DESIGNED BY: E.D., J.B.H.	DRAINAGE & GRADING PLAN FOR U-HAUL CENTER 6401 CENTRAL AVE. N.E.
DRAWN BY: J.B.H. C.V.M.	
CHECKED BY: E.D.	
DATE: Dec. 1986	PREPARED BY: RESOURCE TECHNOLOGY, INC.

RECEIVED NOV 10 1986 HYDROLOGY SECTION

DESIGNED BY: E.D., J.B.H.	DRAINAGE & GRADING PLAN FOR U-HAUL CENTER 6401 CENTRAL AVE. N.E.
DRAWN BY: J.B.H. C.V.M.	
CHECKED BY: E.D.	
DATE: Oct. 1986	PREPARED BY: RESOURCE TECHNOLOGY, INC.

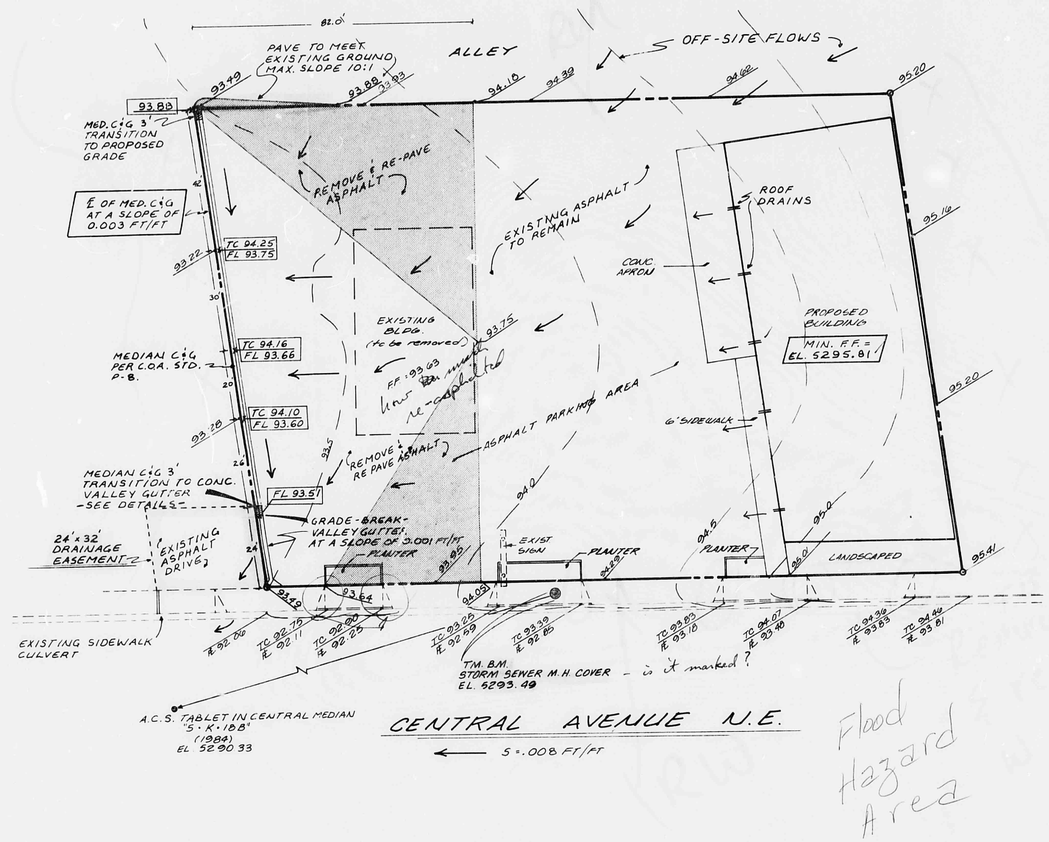
Zone Atlas Page K-18; Flood Hazard Zone ~~X~~ AO - Dep 1

= .9 per E.R.

Present and Proposed
10-yr. = 3,424 cu. ft.
100-yr. = 5,216 cu. ft. K-4774 Dep = 2"

10-yr. = 5.4 cfs
100-yr. = 8.2 cfs 8.1

10-yr. = 9,286 cu. ft.
100-yr. = 14,144 cu. ft. K-12,947
